CONDITIONS OF APPROVAL:

Engineering - PUD Plan Checklist

Colletta Park Development Plan Resubmittal Set 8.3.2017.pdf

66. F. Development Plan

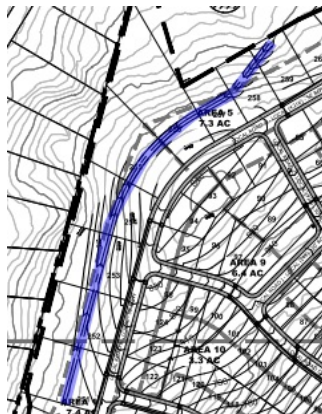
jimmy.wiseman@franklin.tn.gov Applicant shall ensure the right of way for Highway 96 is 52.5' minimum from the centerline of the roadway per the approved TDOT typical section. Additional dedication may be required along site frontage.

67. Solid Waste Service

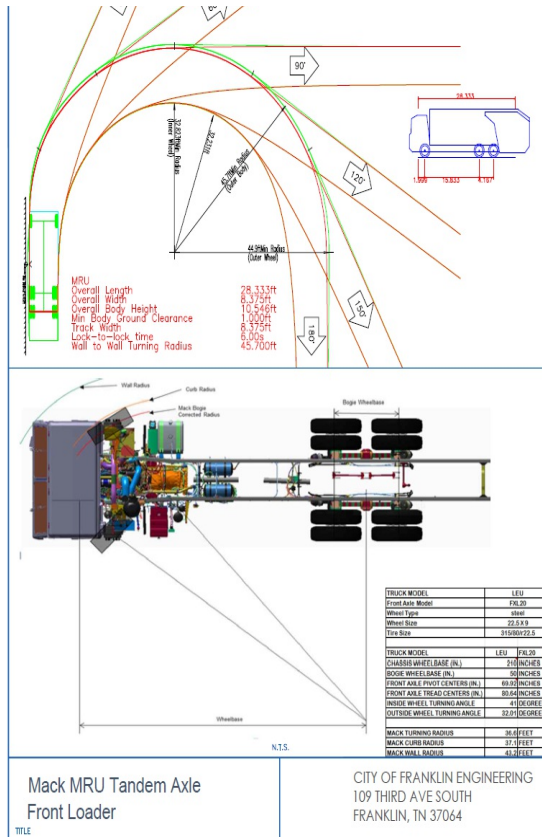
bryan.brown@franklintn.gov Please provide a side-loader auto-turn to service the refuse collection points in the plan. The collection points are most likely going to be in the alleys. The refuse truck will need to be shown entering and exiting all alleys.

Below are the standard specifications for this type collection truck.
